# Side Guard Trailer Detection

## TSB-54-381-FTL

► New Cascadia

Fig. 4, Orange Trailer Air Line and Splice Packs

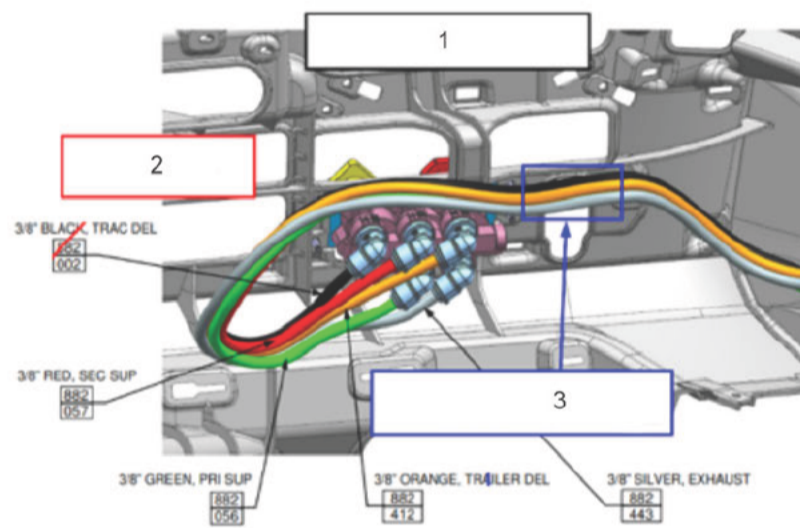
4.  Once the dashboard lower panel is removed, locate and splice the air T with a sensor into the orange trailer delivery line. See Fig. 4 and Fig. 5.
